**RE: Request for Further Information
Lingard Private Hospital Expansion (SSD-60316710)**

This letter is submitted to the Department of Department of Planning, Housing and Infrastructure in response to the Request for Further Information (RFI) issued on 10 December 2024, relating to SSD-60316710 for the proposed expansion of the Lingard Private Hospital.

Table 1 City of Newcastle

Figure 1 – Existing Shadow (3pm)

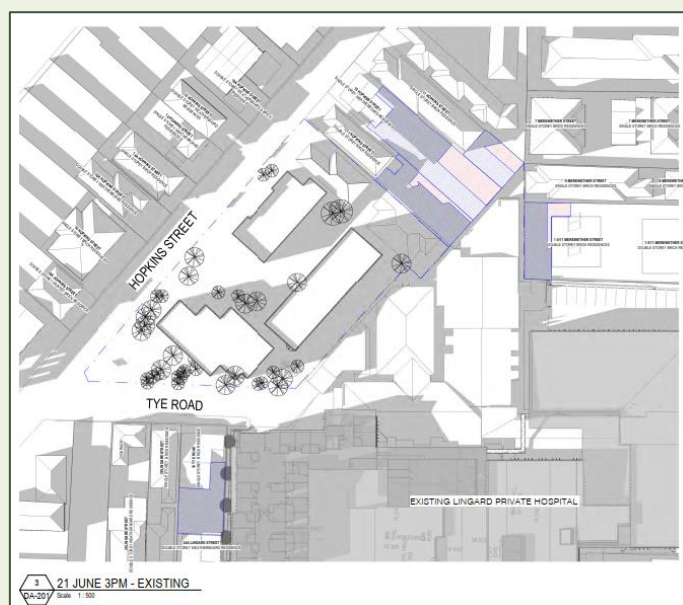
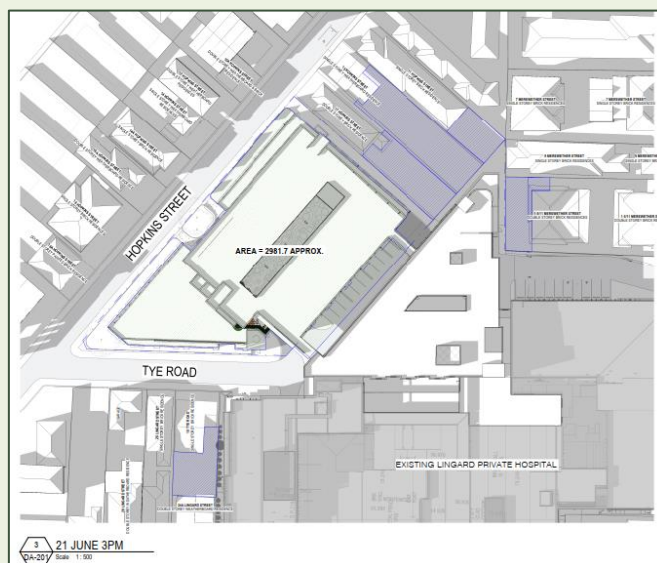
CN's concerns regarding residential amenity remain. The amended architectural plans do not include hourly shadow diagrams or 3D shadow analysis to identify the habitable rooms and private open space of residential properties, as previously requested. The shadow impact to Mitchell Park has not been adequately addressed.

These shadow impacts result from the development's bulk and scale. CN recommends the design be amended to reduce the bulk and scale, and include larger setbacks, particularly at upper floor levels.

The amended shadow diagrams include percentage calculations for the surrounding residential dwellings and confirm compliance. The most significant impact is on 11 Merewether Street in the afternoon; however, the existing shadow diagrams show that this is also the present state, refer to Figure 1 & 2 below. In the previous iteration of plans the second level wall was also setback further from this boundary.

The proposal does affect the adjoining Hopkins Street dwellings at 3 PM; however, there is no impact during the morning hours. The proposed setbacks are consistent with the existing dwelling setbacks in the area. While there is some overshadowing in the afternoon, the dwellings receive sufficient sunlight in the morning,

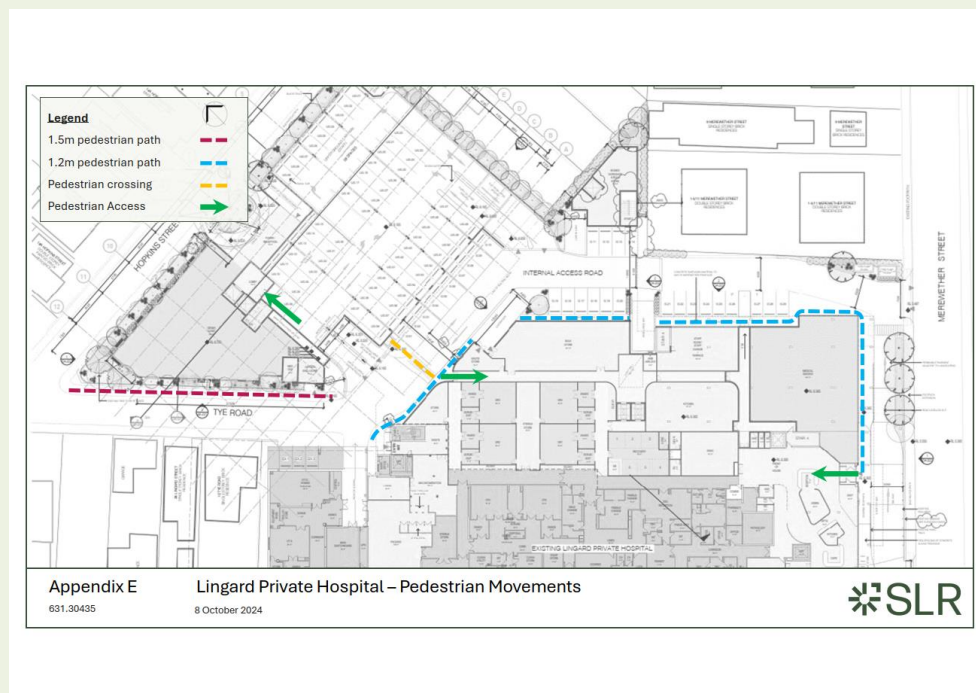
- *The Tye Road extension provides legal vehicular and pedestrian access rights over the private section of the road and ensures 24/7 access to the public under Part E, Section E12 of the NDCP 2023 and AS1742.10.*
- *The provision of safe, connected pedestrian movements and footway access between Tye Road to Merewether Street via the Lingard Street Precinct under Part E, Section E12 of the NDCP 2023.*
- *Provision for a turning head at the southern limit of the public road component for instances where the private component of Tye Road is closed under BAU conditions by the operator.*
- *Driveways on Merewether Street upgraded to provide continuous footpath treatments similar to Cooper Street, Newcastle West or Steel Lane off Hunter Street.*

Response: The proposal does not propose any traffic restriction measures, such as gates across the Tye Road access, there will be no instances where the road is closed off or requirements for this under business-as-usual operation.

Appendix E of the previous traffic response showed the pedestrian movements from Tye Road to Merewether Street, extract below. There will be no times under normal operation when this access is unavailable.

The north side of Merewether Street has a continuous footpath and part of the works required under the VPA include a continuous footpath along the south portion of Merewether Street, to Mitchell Street.
